02 Landscape Redesign: Proposal Overview

Fig 2: 3340 - PL(00)013 Pears Building Level 02 Plan - Proposed amendment of landscape scheme

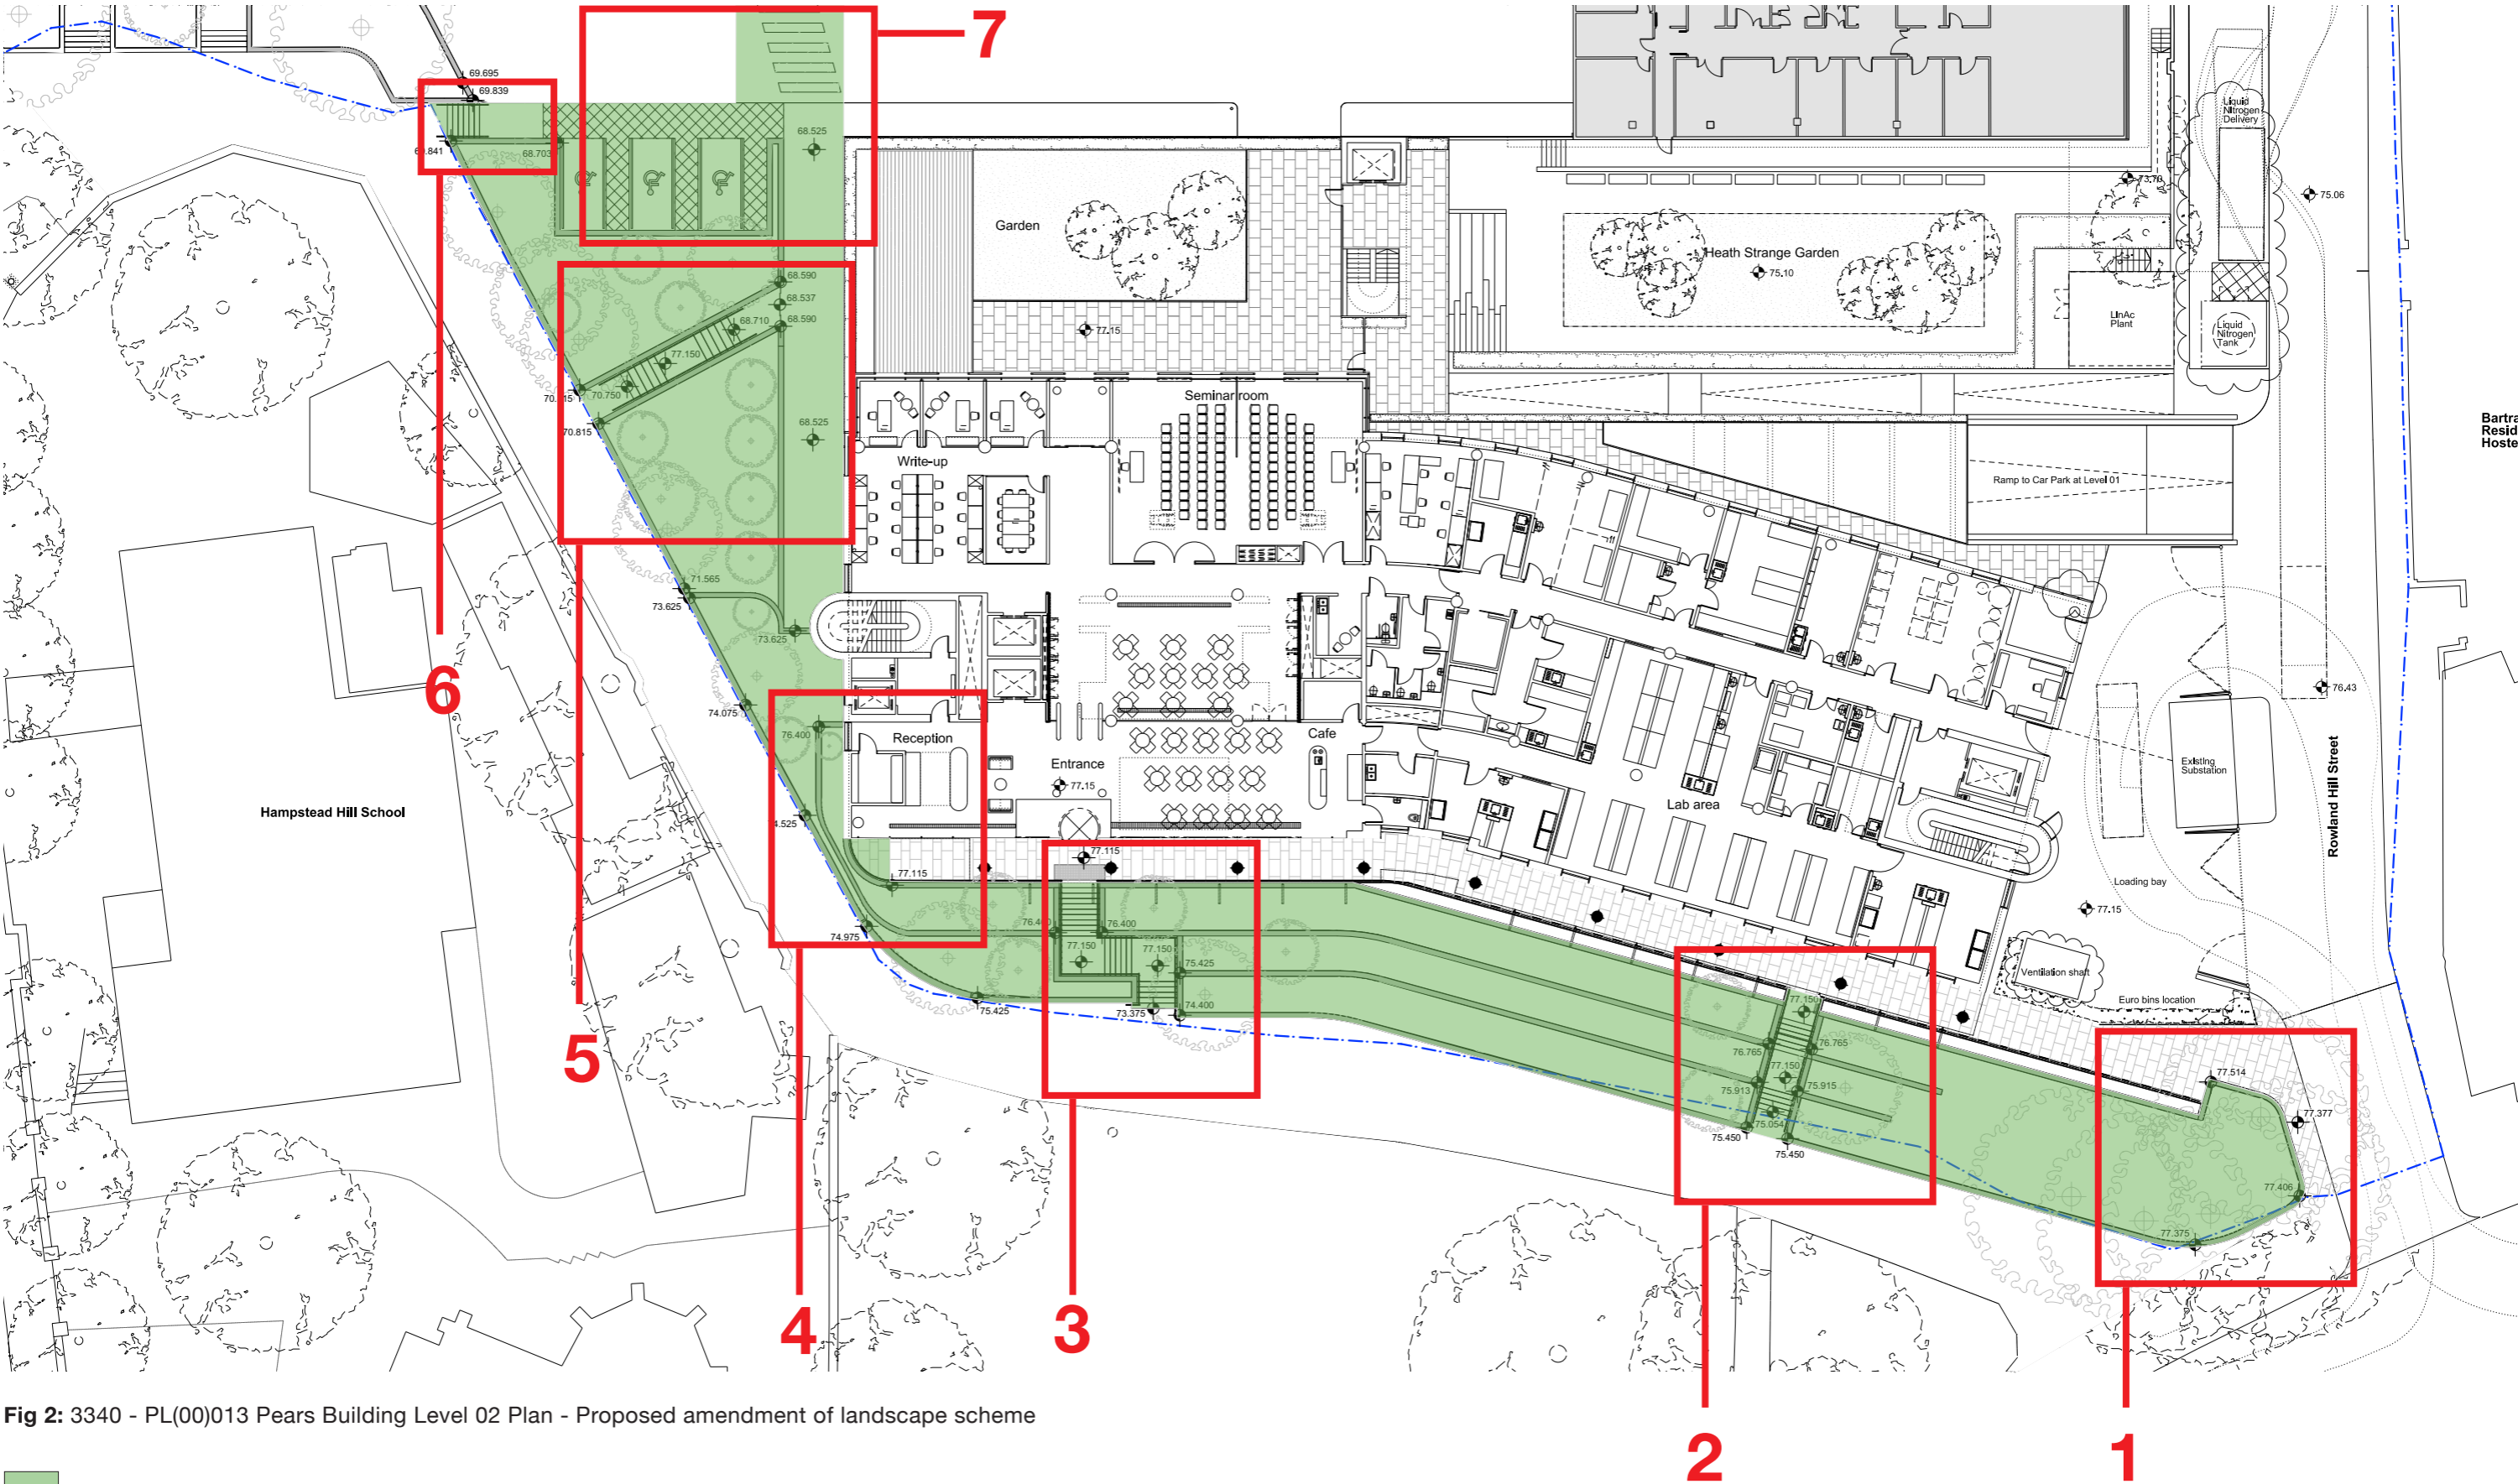
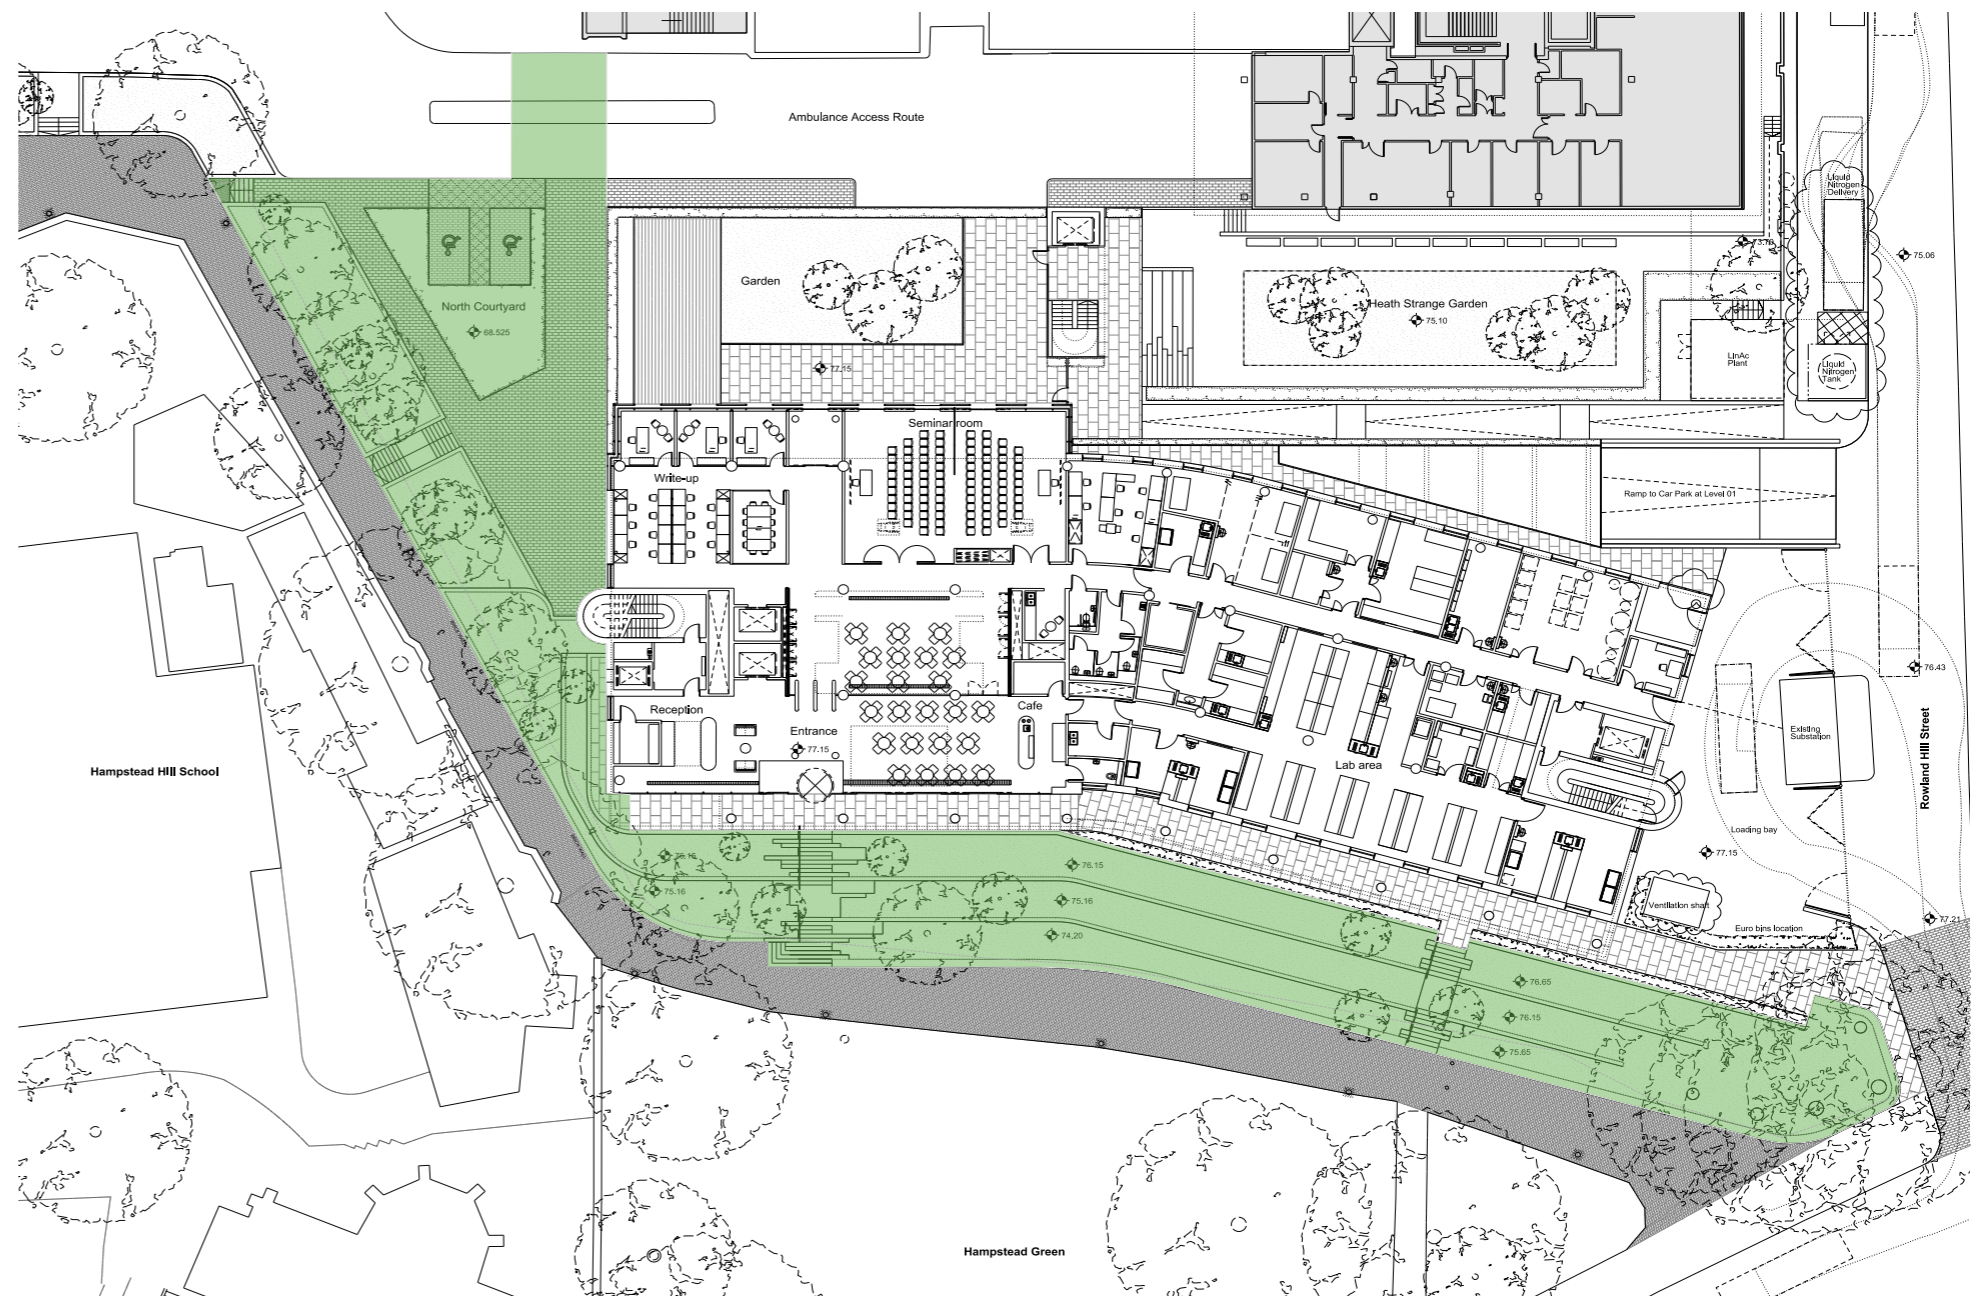
(1) Section of low kerb to minimise disturbance to existing trees.

Note: low level brick wall has been discussed, but existing tree roots appear too close to the edge to allow for the construction of a wall.

(2) Stair pushed back to accommodate the reduced width of the proposed landscape / side walls removed.

(3) Shape of main entrance stair revised to accommodate the level change with the reduced width of the proposed landscape/ side walls removed.

Note: the new stair arrangement improves visibility of pedestrians coming around the corner and of people using the stair.

(4) North-West corner revised:

4.1 Retaining walls pushed back.

4.2 External hard-paved terrace stopped at the edge of the building (wrapped around the building before).

Note: changes required, in order to accommodate the reduced width of the proposed landscape.

4.3 Access to exterior from lift removed. Lift to open to the interior of the building instead.

4.4 Canopy removed, since there is no need for it, following the removal of the north section of the external terrace.

Note: changes dictated by the removal of the north section of the external hard-paved terrace.

4.5 Lowest retaining brick wall lowered by staggering at equal intervals.

(5) Staircase / Landscape and courtyard reconfigured

5.1 Staircase reconfigured to accommodate reduced width of the proposed landscape. Staircase relocated to align with the entrance of the Charity Offices.

5.2 Landscape pushed back to accommodate the reduced width of the proposed landscape.

5.3 North Courtyard removed and replaced with soft landscaping.

5.4 Path along the building retained.

(6) Staircase moved and made wider to align retaining wall with the car park spaces.

(7) Car park space and pedestrian crossing

7.1 One additional car park space added.

7.2 New pedestrian crossing proposed for the ambulance access route. Existing hard standing to be removed.
